**U.S. ARMY ENGINEER DIVISION
HUNTSVILLE, ALABAMA**

**DECISION DOCUMENT FOR REMOVAL ACTIONS
AT SWMUs SEAD-11, SEAD-25, SEAD-26, SEAD-38,
SEAD-39, SEAD-40, AND SEAD-41, SENECA ARMY
DEPOT ACTIVITY**

AUGUST 1995

COMMENTS AND RECOMMENDATIONS
PRE-DRAFT DECISION DOCUMENT FOR REMOVAL ACTION AT SWMU'S
SEAD-11, SEAD-25, SEAD-26, SEAD-38,
SEAD-39, SEAD-40, AND SEAD-41
SENECA ARMY DEPOT ACTIVITY
ROMULUS, NY
JANUARY 1995

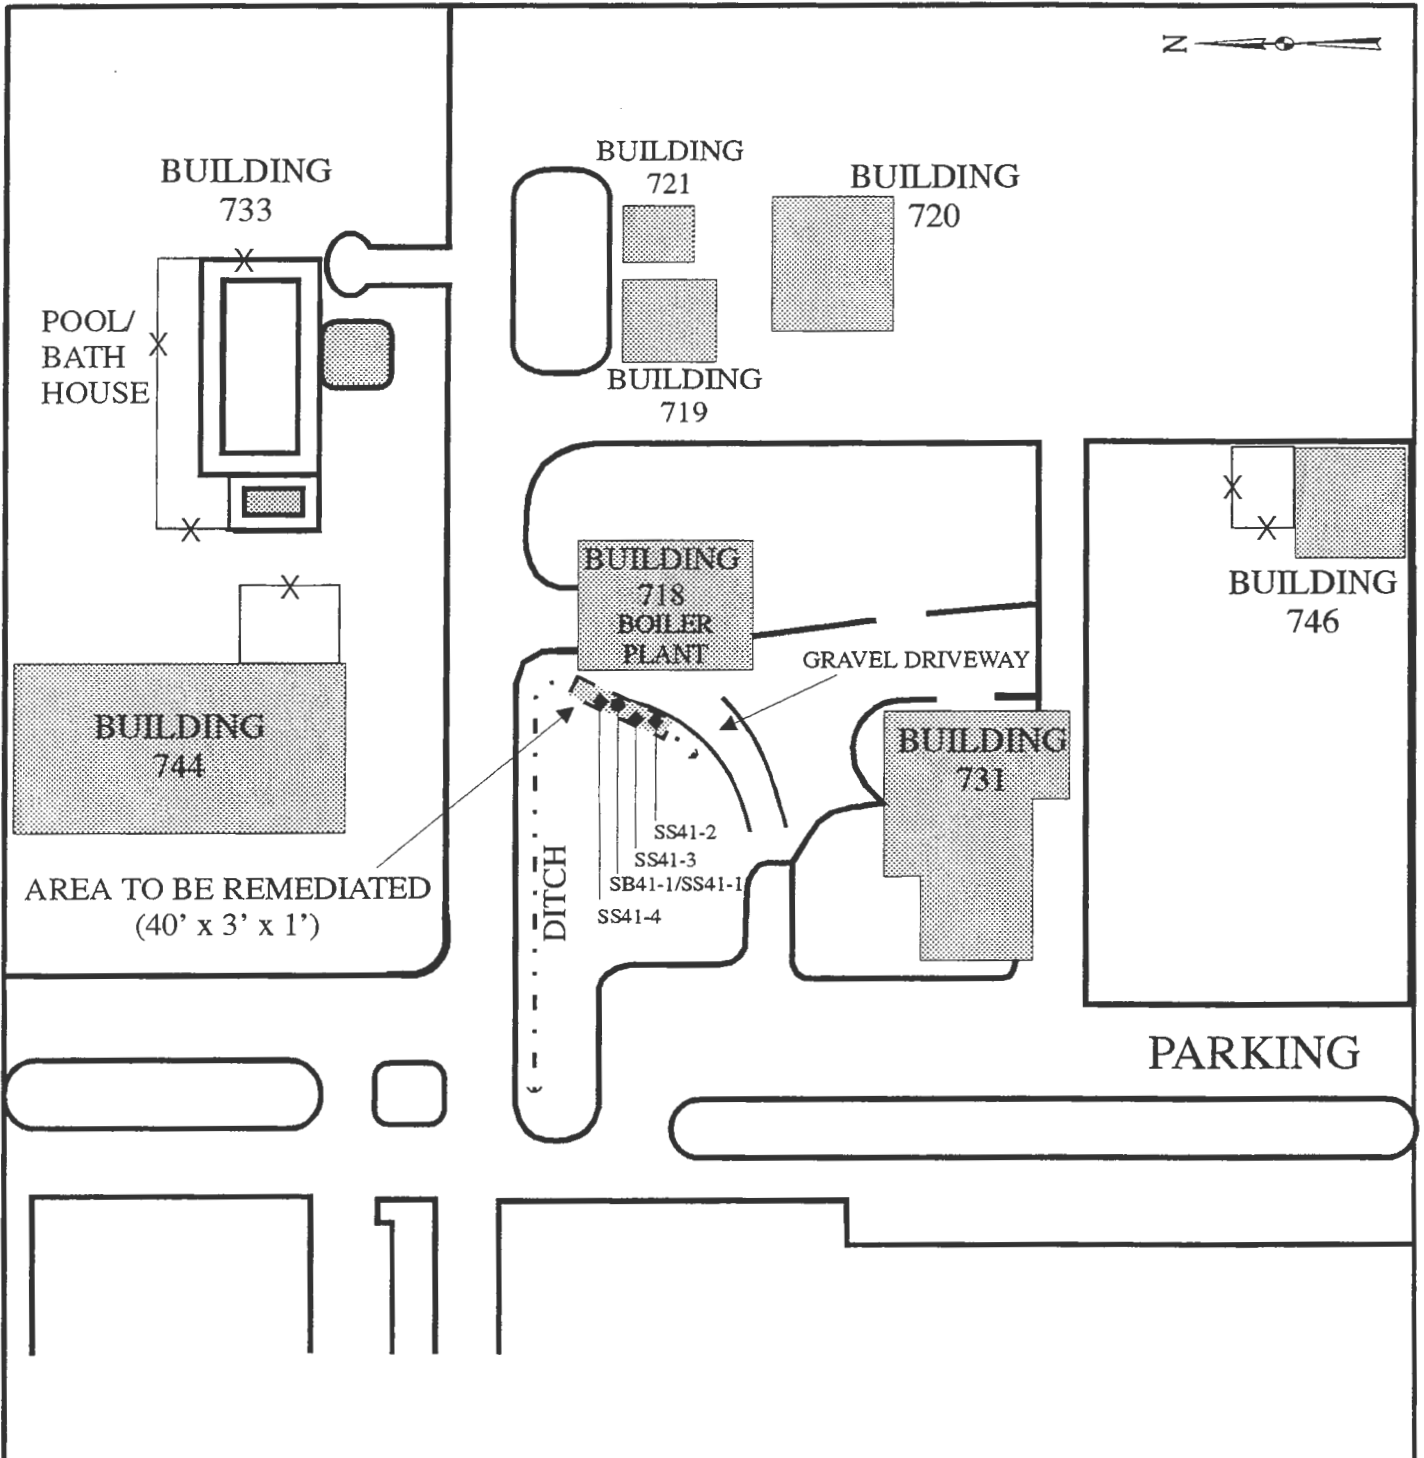
Comment #14

Response #14

Agree. Figure 1 in Section 7 has been modified to better reflect the written description in Section 7.2.1.
